# Hi-Fi Products Service Bulletin

**Model:** All CDP/CDP-C

**No.** 286R1

**Subject:** Will Not Play Disc / Skips After Optical Block Replacement

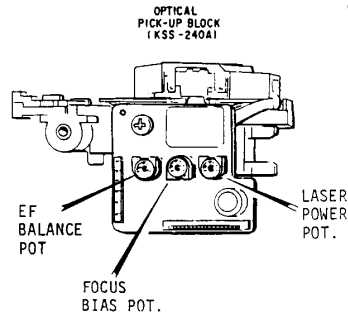
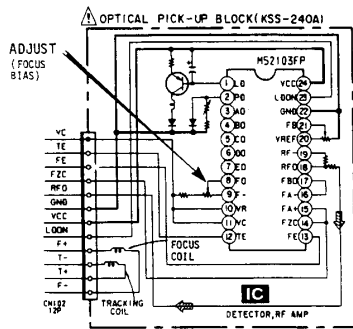
**Symptom:**  
(12) Unit will not read TOC or unit will skip after optical block has been replaced.

**Solution:** Focus Bias is out of adjustment. Adjust focus bias pot on optical block KSS-240A as follows:

1. Use a YEDS-18 disc.
2. Adjust the focus bias pot for the clearest eye pattern.

Clear RF signal waveform means that the shape "◇" can be clearly distinguished at the center of the waveform.
